**SUSQUEHANNA STEAM ELECTRIC STATION
PROPOSED AMENDMENT NO. 254 TO LICENSE NFP-14
AND PROPOSED AMENDMENT NO. 219 TO LICENSE NFP-22:
REVISED RESPONSE TO GL 94-02:
LONG-TERM STABILITY SOLUTION
PLA-5620**

REVISED RESPONSE TO GL 94-02: LONG-TERM STABILITY SOLUTION

**Proposed Technical Specification Changes
(Markups)**

Figure 3.4.1-1

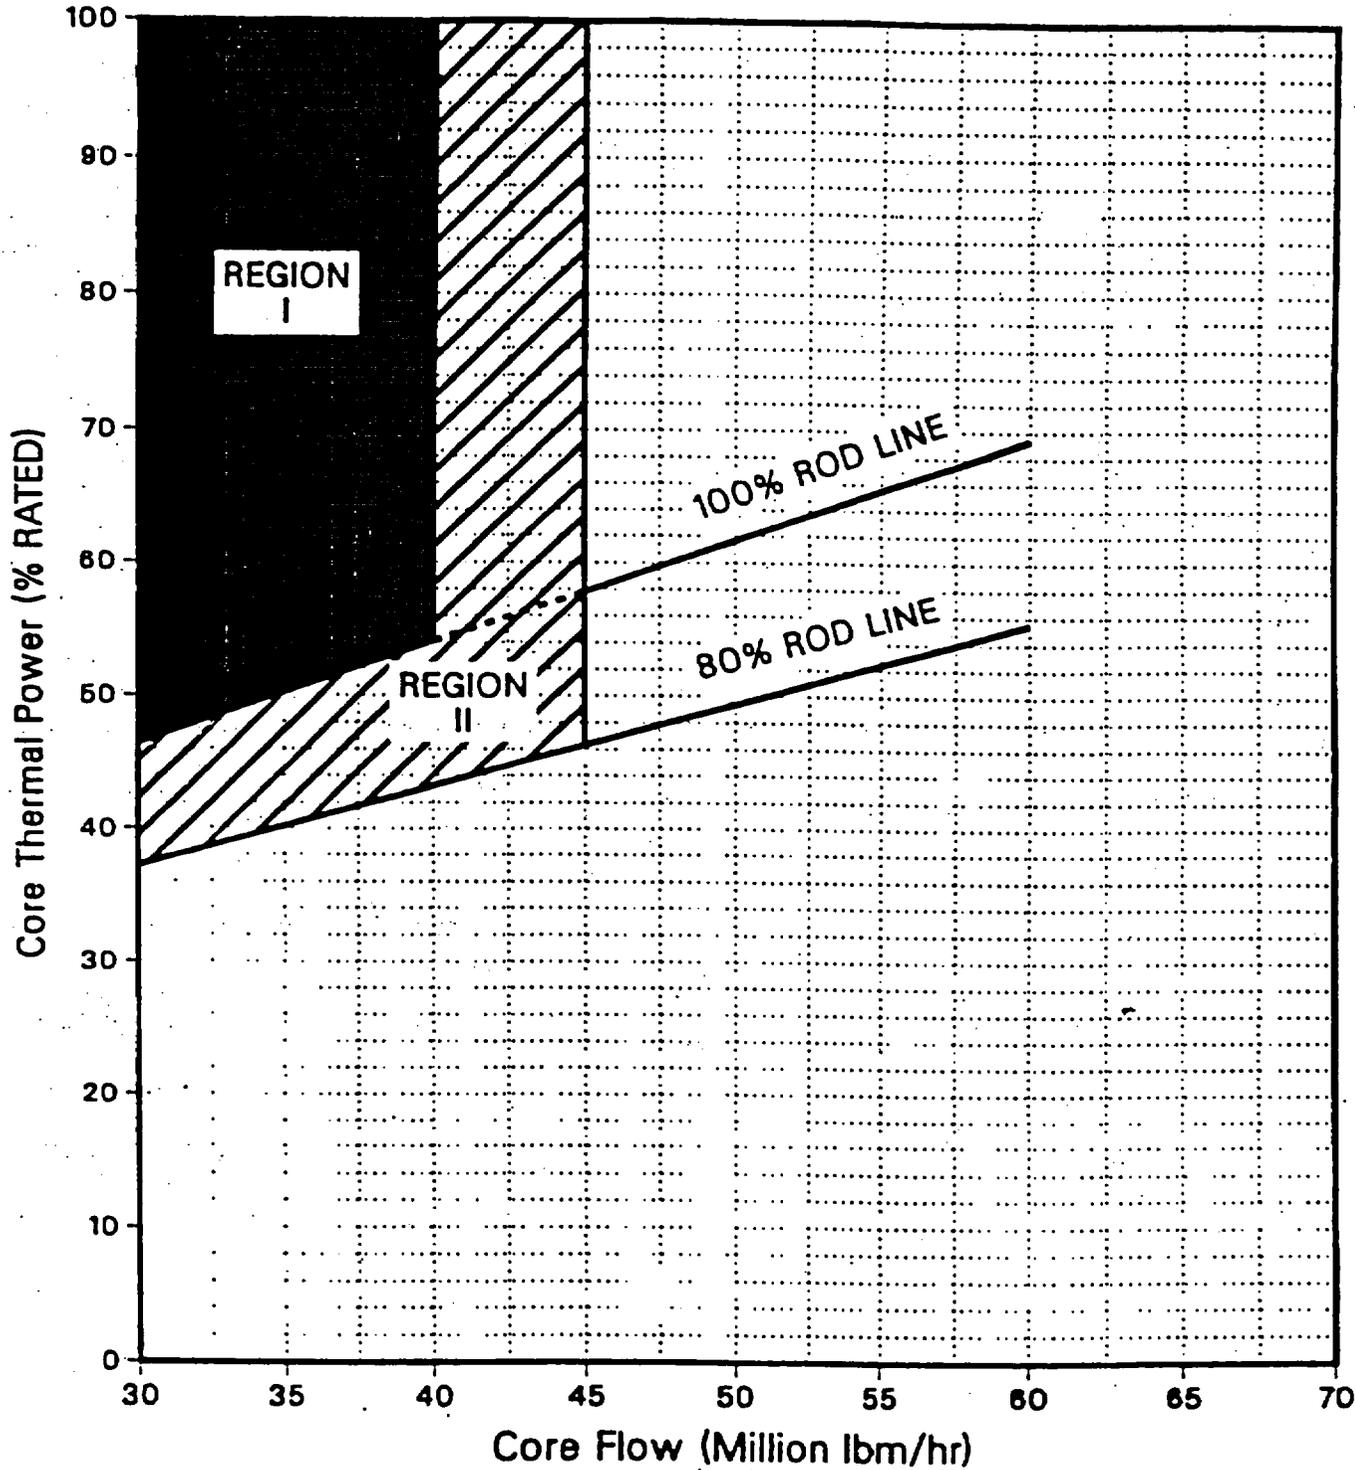
LCO 3.4.1 Two recirculation loops with matched flows shall be in operation with a THERMAL POWER/core flow condition outside of Regions I and II of Figure 3.4.1-1.

One recirculation loop may be in operation provided the following limits are applied when the associated LCO is applicable with a THERMAL POWER/core flow condition outside of Regions I and II of Figure 3.4.1-1.

CONDITION	REQUIRED ACTION	COMPLETION TIME
<p>A. Total core flow as a function of THERMAL POWER within Region I of Figure 3.4.1-1.</p> <p><u>OR</u></p> <p>No recirculation loops operating while in MODE 1</p>	<p>A.1 Place reactor mode switch in the shutdown position.</p>	<p>Immediately</p>
<p>B. -----NOTE----- Only applicable when in Region II of Figure 3.4.1-1</p> <p>Two or more APRM readings oscillating with one or more oscillating $\geq 10\%$ of RTP peak-to-peak.</p> <p><u>OR</u></p> <p>Two or more LPRM upscale alarms activating and deactivating with a period ≥ 1 second and ≤ 5 seconds.</p> <p><u>OR</u></p> <p>Sustained LPRM oscillations > 10 w/cm² peak-to-peak with a period ≥ 1 second and ≤ 5 seconds.</p> <p><u>OR</u></p>	<p>B.1 Place the reactor mode switch in the shutdown position.</p>	<p>Immediately</p> <p>(continued)</p>

CONDITION	REQUIRED ACTION	COMPLETION TIME
B. (continued) Less than 50% of required LPRM upscale alarms OPERABLE (4)		
C. Total core flow as a function of THERMAL POWER within Region II of Figure 3.4.1-1.	C.1 Initiate action to restore total core flow as a function of THERMAL POWER outside of Region II.	Immediately
D. Recirculation loop flow mismatch not within limits.	D.1 Declare the recirculation loop with lower flow to be "not in operation."	2 hours
E. No recirculation loops in operation while in MODE 2 (3) <u>OR</u> Single Recirculation Loop required limits and setpoints not established within required time.	E.1 Be in MODE 3.	12 hours

Figure 3.4.1-1

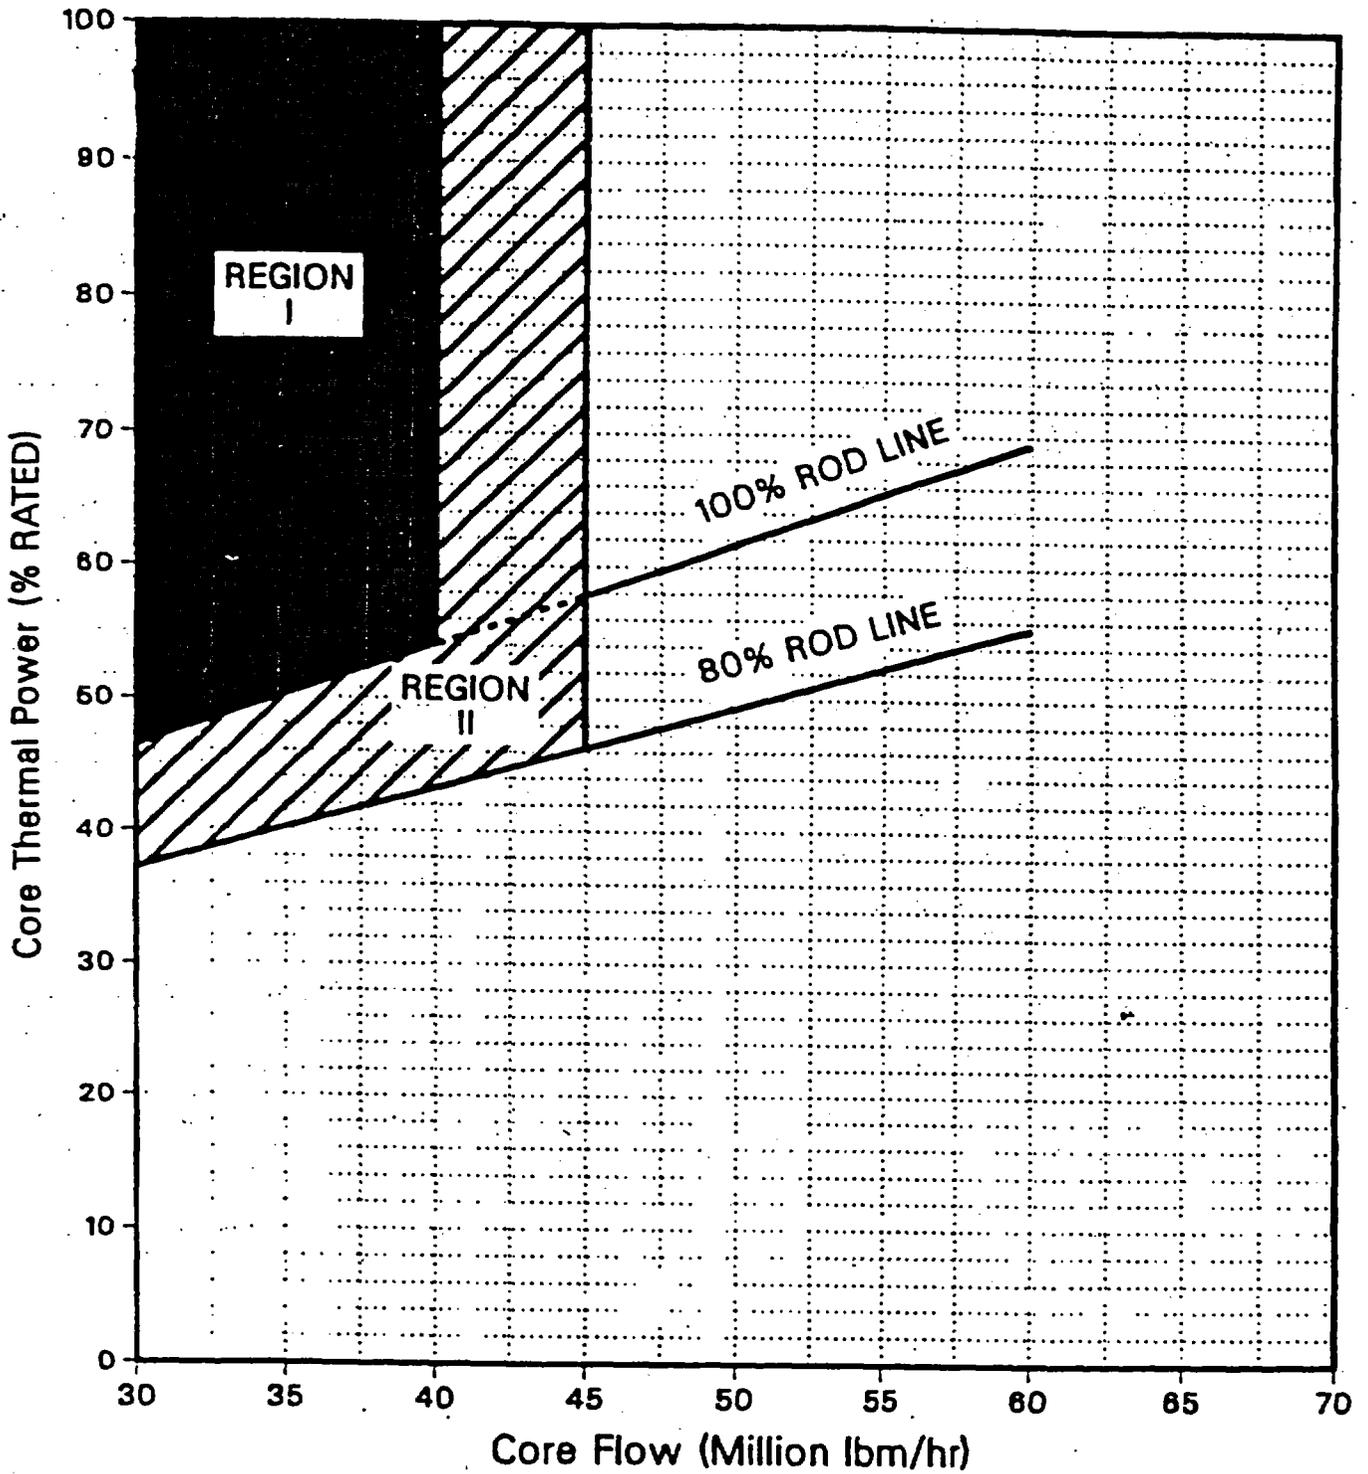
LCO 3.4.1 Two recirculation loops with matched flows shall be in operation with a THERMAL POWER/core flow condition outside of Regions I and II of Figure 3.4.1-1.

One recirculation loop may be in operation with a THERMAL POWER/core flow condition outside of Regions I and II of Figure 3.4.1-1 provided the following limits are applied when the associated LCO is applicable:

CONDITION	REQUIRED ACTION	COMPLETION TIME
<p>A. Total core flow as a function of THERMAL POWER within Region I of Figure 3.4.1-1.</p> <p><u>OR</u></p> <p>No recirculation loops operating while in MODE 1</p>	<p>A.1 Place reactor mode switch in the shutdown position.</p>	<p>Immediately</p>
<p>B. -----NOTE----- Only applicable when in Region II of Figure 3.4.1-1</p> <p>Two or more APRM readings oscillating with one or more oscillating $\geq 10\%$ of RTP peak-to-peak.</p> <p><u>OR</u></p> <p>Two or more LPRM upscale alarms activating and deactivating with a period ≥ 1 second and ≤ 5 seconds.</p> <p><u>OR</u></p> <p>Sustained LPRM oscillations > 10 w/cm² peak-to-peak with a period ≥ 1 second and ≤ 5 seconds.</p> <p><u>OR</u></p>	<p>B.1 Place the reactor mode switch in the shutdown position.</p>	<p>Immediately</p> <p>(continued)</p>

CONDITION	REQUIRED ACTION	COMPLETION TIME
B. (continued) Less than 50% of required LPRM upscale alarms OPERABLE		
C. Total core flow as a function of THERMAL POWER within Region II of Figure 3.4.1-1.	C.1 Initiate action to restore total core flow as a function of THERMAL POWER outside of Region II.	Immediately
D. Recirculation loop flow mismatch not within limits.	D.1 Declare the recirculation loop with lower flow to be "not in operation."	2 hours
E. No recirculation loops in operation while in MODE 2 <u>OR</u> Single Recirculation Loop required limits and setpoints not established within required time.	E.1 Be in MODE 3.	12 hours

Figure 3.4.1-1
Thermal Power Stability Restrictions

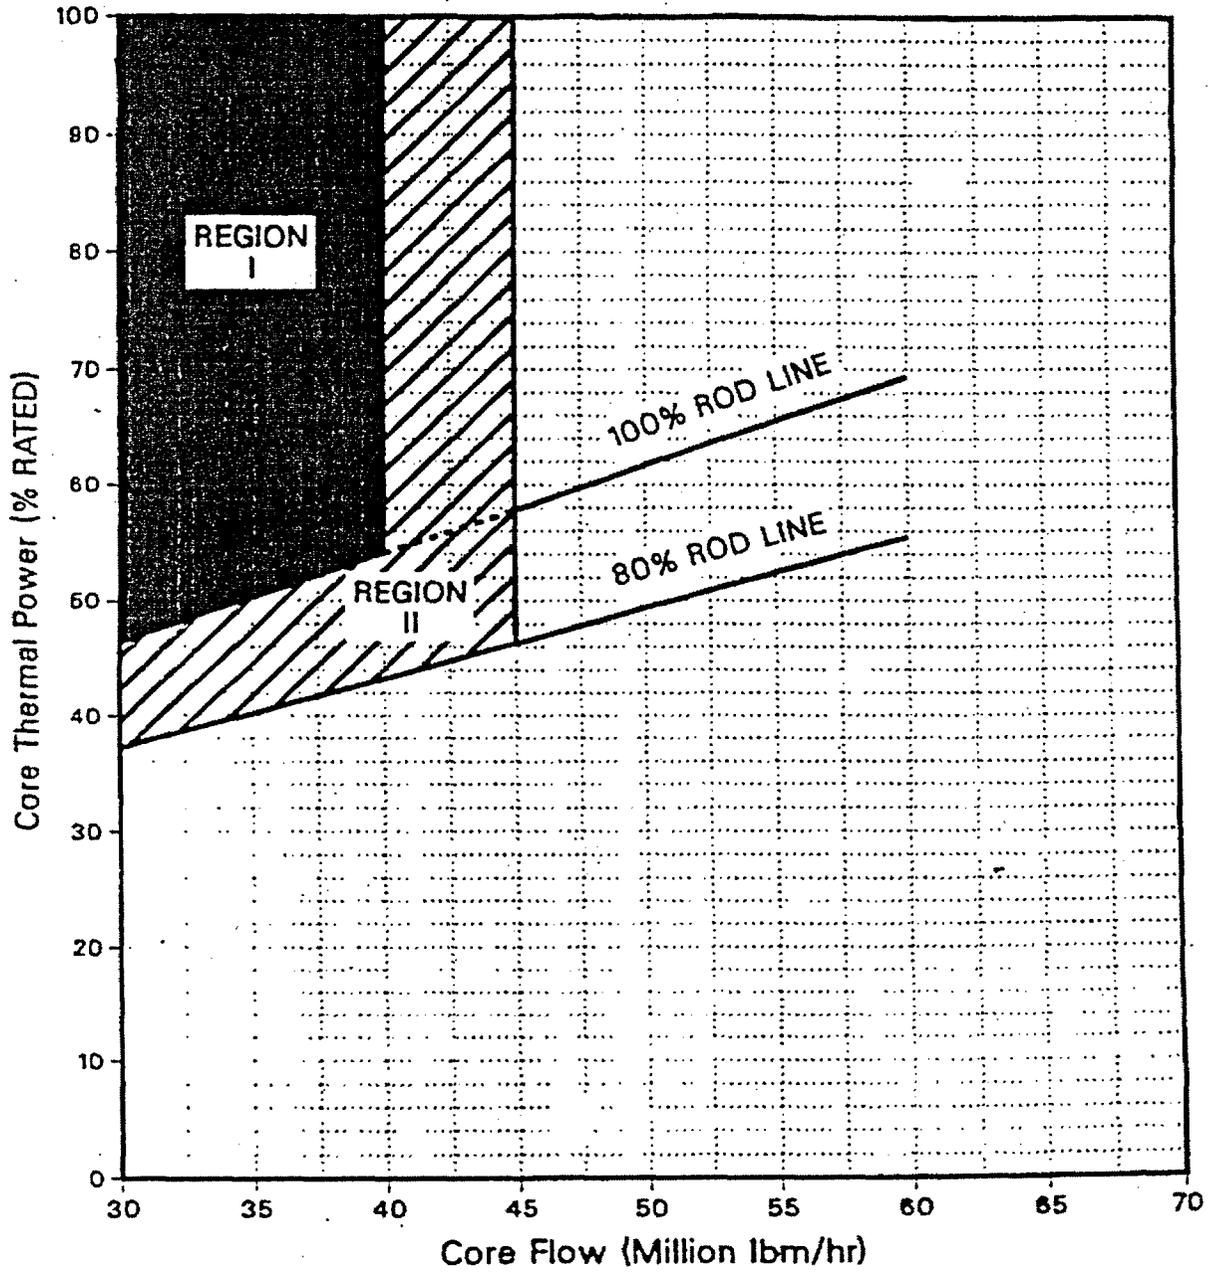
LCO 3.4.1 Two recirculation loops with matched flows shall be in operation with a THERMAL POWER/core flow condition outside of Regions I and II of Figure 3.4.1-1.

One recirculation loop may be in operation with a THERMAL POWER/core flow condition outside of Regions I and II of Figure 3.4.1-1 provided the following limits are applied when the associated LCO is applicable.

ACTIONS		
CONDITION	REQUIRED ACTION	COMPLETION TIME
<p>A. Total core flow as a function of THERMAL POWER within Region I of Figure 3.4.1-1.</p> <p><u>OR</u></p> <p>No recirculation loops operating while in MODE 1.</p>	<p>A.1 Place reactor mode switch in the shutdown position.</p>	<p>Immediately</p>
<p>B. -----NOTE----- Only applicable when in Region II of Figure 3.4.1-1. -----</p> <p>Two or more APRM readings oscillating with one or more oscillating $\geq 10\%$ of RTP peak-to-peak.</p> <p><u>OR</u></p> <p>Two or more LPRM upscale alarms activating and deactivating with a period ≥ 1 second and ≤ 5 seconds.</p> <p><u>OR</u></p> <p>Sustained LPRM oscillations $> 10 \text{ w/cm}^2$ peak-to-peak with a period ≥ 1 second and ≤ 5 seconds.</p> <p><u>OR</u></p> <p>Less than 50% of required LPRM upscale alarms OPERABLE.</p>	<p>B.1 Place the reactor mode switch in the shutdown position.</p>	<p>Immediately</p>

CONDITION	REQUIRED ACTION	COMPLETION TIME
C. Total core flow as a function of THERMAL POWER within Region II of Figure 3.4.1-1.	C.1 Initiate action to restore total core flow as a function of THERMAL POWER outside of Region II.	Immediately
D. Recirculation loop flow mismatch not within limits.	D.1 Declare the recirculation loop with lower flow to be "not in operation."	2 hours
E. No recirculation loops in operation while in MODE 2. <u>OR</u> Single Recirculation Loop required limits and setpoints not established within required time.	E.1 Be in MODE 3.	12 hours

Figure 3.4.1-1

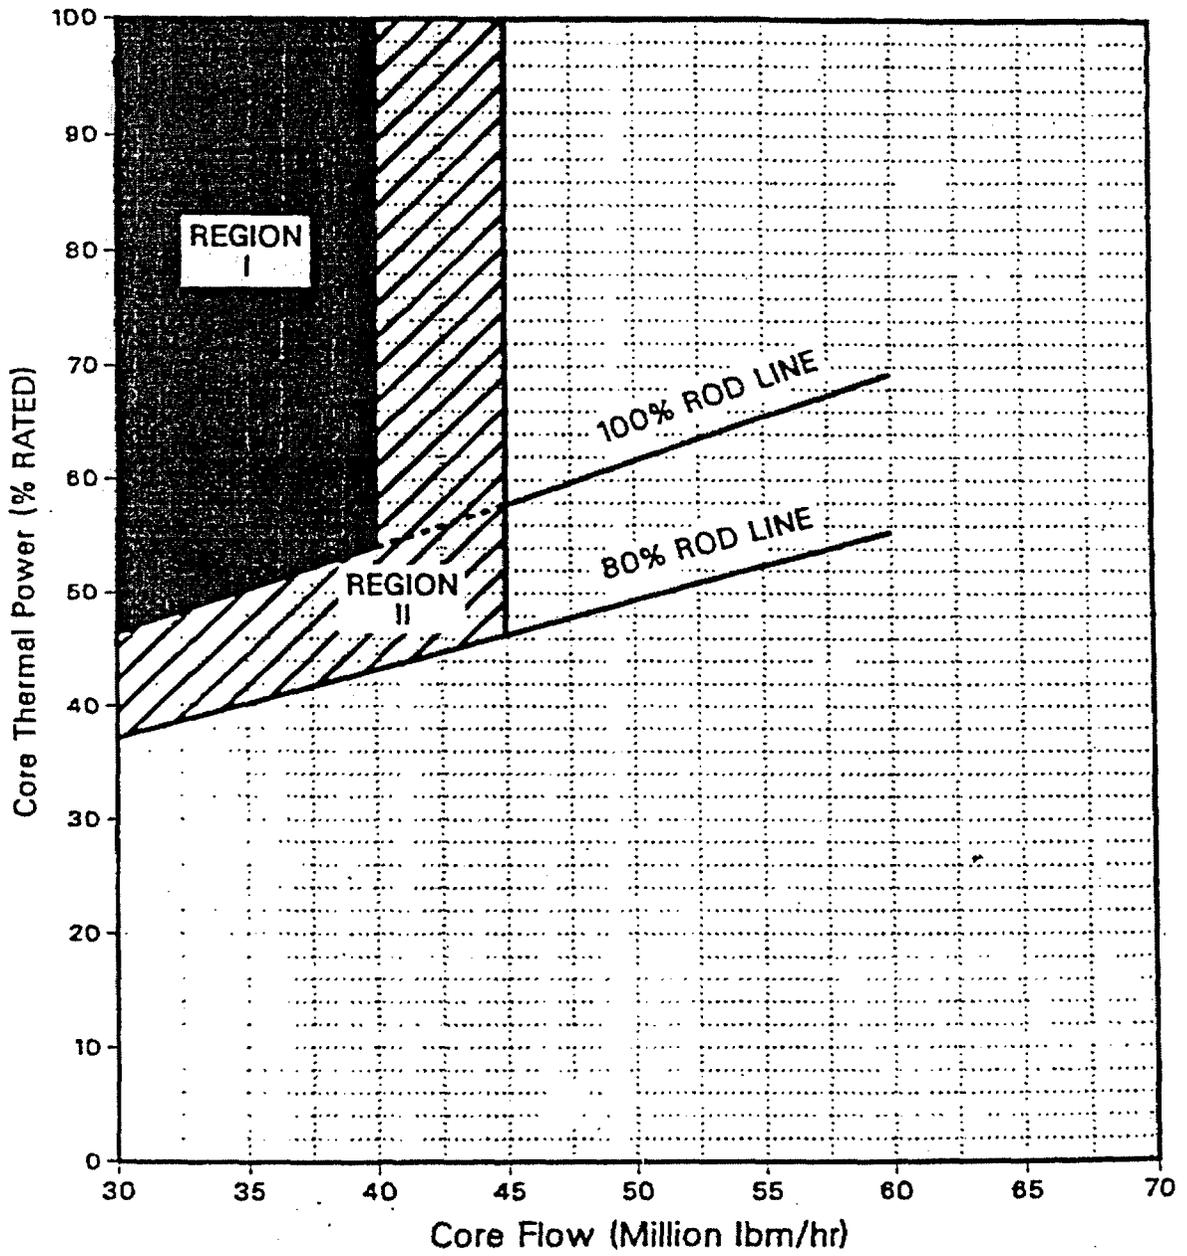
LCO 3.4.1 Two recirculation loops with matched flows shall be in operation with a THERMAL POWER/core flow condition outside of Regions I and II of Figure 3.4.1-1.

One recirculation loop may be in operation with a THERMAL POWER/core flow condition outside of Regions I and II of Figure 3.4.1-1 provided the following limits are applied when the associated LCO is applicable:

ACTIONS		
CONDITION	REQUIRED ACTION	COMPLETION TIME
<p>A. Total core flow as a function of THERMAL POWER within Region I of Figure 3.4.1-1.</p> <p><u>OR</u></p> <p>No recirculation loops operating while in MODE 1.</p>	<p>A.1 Place reactor mode switch in the shutdown position.</p>	<p>Immediately</p>
<p>B. -----NOTE----- Only applicable when in Region II of Figure 3.4.1-1.</p> <hr/> <p>Two or more APRM readings oscillating with one or more oscillating $\geq 10\%$ of RTP peak-to-peak.</p> <p><u>OR</u></p> <p>Two or more LPRM upscale alarms activating and deactivating with a period ≥ 1 second and ≤ 5 seconds.</p> <p><u>OR</u></p> <p>Sustained LPRM oscillations $> 10 \text{ w/cm}^2$ peak-to-peak with a period ≥ 1 second and ≤ 5 seconds.</p> <p><u>OR</u></p> <p>Less than 50% of required LPRM upscale alarms OPERABLE.</p>	<p>B.1 Place the reactor mode switch in the shutdown position.</p>	<p>Immediately</p>

CONDITION	REQUIRED ACTION	COMPLETION TIME
C. Total core flow as a function of THERMAL POWER within Region II of Figure 3.4.1-1.	C.1 Initiate action to restore total core flow as a function of THERMAL POWER outside of Region II.	Immediately
D. Recirculation loop flow mismatch not within limits.	D.1 Declare the recirculation loop with lower flow to be "not in operation."	2 hours
E. No recirculation loops in operation while in MODE 2. <u>OR</u> Single Recirculation Loop required limits and setpoints not established within required time.	E.1 Be in MODE 3.	12 hours
